E. R. Squibb & Sons, Inc.

This is in response to your letter of February 18, 1982 in which you requested additional information with respect to Squibb's Radiological Contingency Plan. Each of your comments have been addressed in the enclosure. Also included are additional or replacement pages for the required information.

Response to Comments on Squibb's Radiological Contingency Plan

MANFRED HANSJOACHIM RIEDEL AIA
CONSULTING ARCHITECT

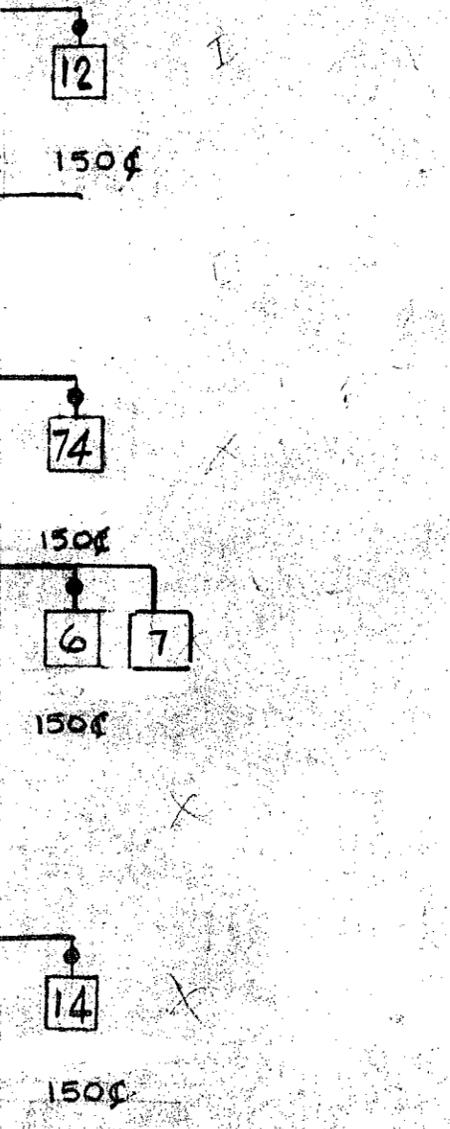
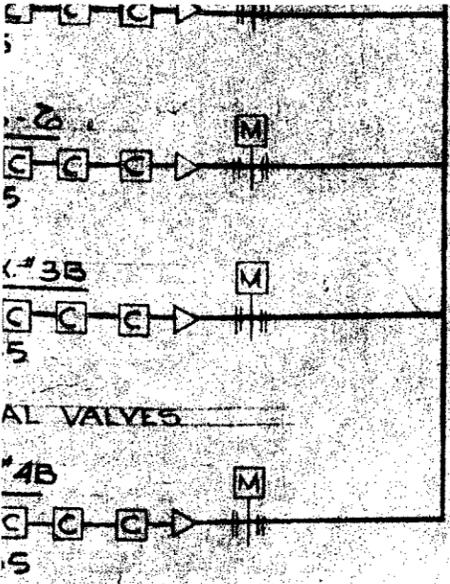
Schematic drawings showing the relationships among the glove boxes, fume hoods, hot cells and filter banks with associated ducting have been referenced in this section.

These drawings have been added as an addendum to the plan.
